LIPPERT
COMPONENTS®

March 27, 2018

Product Upgrade Notice – 2" Tow/Accessory Receiver Cross Tube

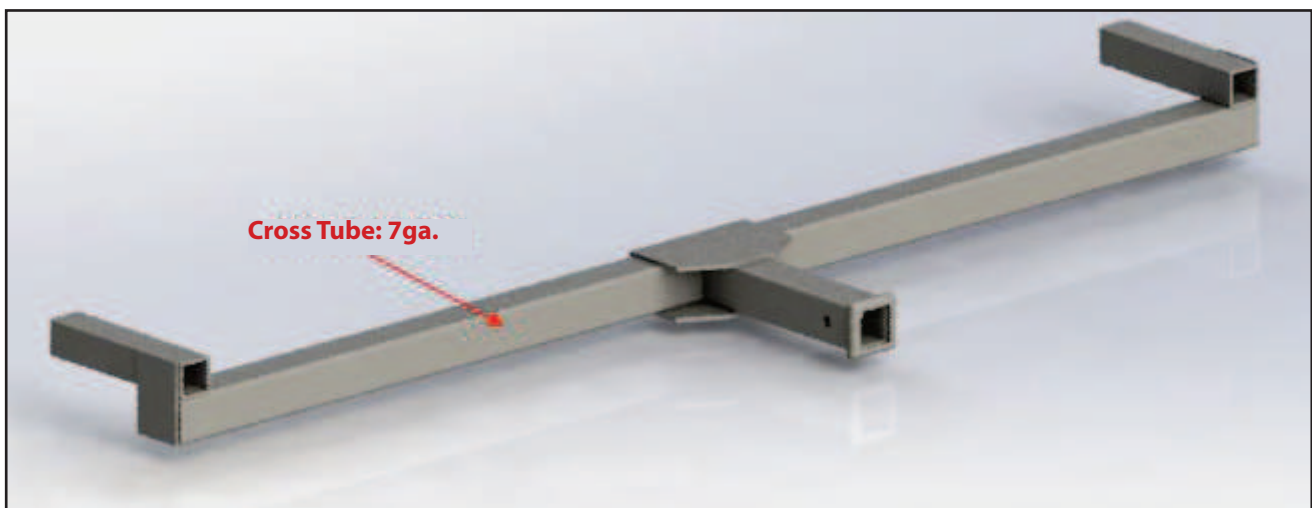
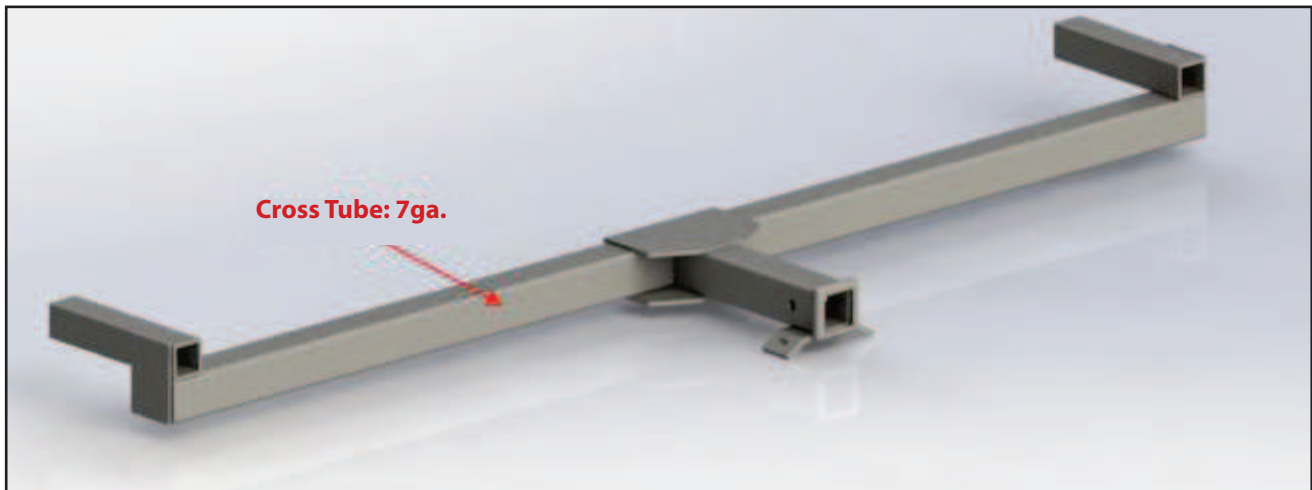
LCI has created new versions of both the 2" towing and 2" accessory receiver hitches with a lighter gauge cross tube. The new 2" towing and accessory hitches will be rated as follows:

- 2" towing hitches = 300 pound hitch weight capacity and 3,500 lb towing capacity; and
- 2" accessory hitches = 300 pound hitch weight capacity and (N/A) towing capacity.

Please note that the new towing hitch will be lighter weight while simultaneously increasing the towing capacity from 3,000 lbs to 3,500 lbs. The original version of the towing and accessory hitches utilized a 0.25" wall tube. The new versions will utilize a 7 ga. wall cross tube.

The new 2" towing and accessory receivers were tested to meet or exceed SAE J684, Table 3 parameters. A copy of the testing reports will be made available to you upon request.
